**RECREATIONAL VEHICLE
SAFETY RECALL NOTICE**

Safety Recall: 23V-822
Safety Advisory: 23-447
April 22, 2026

IMPORTANT SAFETY RECALL – 6th Notice

Figure 1

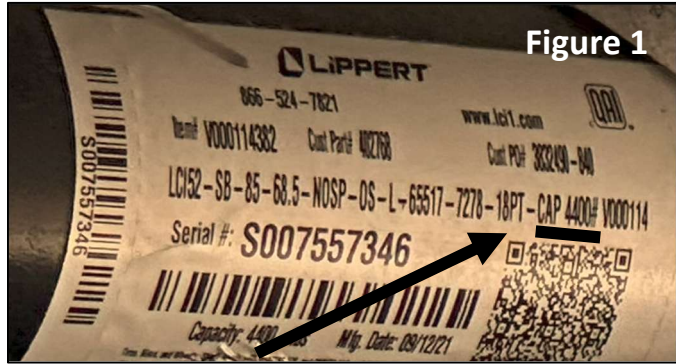
It has been decided that the vehicles in the recall population may have axle springs rated at 4400 pounds rather than the 5100 pound axle rating as specified on Federal Identification Tag. The axles installed had the wrong size springs. Under certain conditions during travel, undersized axle springs can be overloaded leading to an increased risk of axle spring failure and increasing the risk of a crash.

You may choose to self-inspect the axle's tags. If the tag reads as CAP 4400#, as shown in Figure 1, as soon as possible, please make an appointment to have your RV serviced by your dealership. Customers should unload all cargo and empty holding tanks (fresh water, grey water, black water, and water heater) and take their unit to an authorized dealer for remedy of the incorrectly installed axles springs. The labor

Keystone representatives have been in contact with the staff at your selling dealership regarding this situation. The remedy is to replace under rated 4400 LB springs with the correct size 5100 LB springs. This would require both 2200 LB springs be replaced. The service and parts required for this corrective action will be provided at no charge to you.
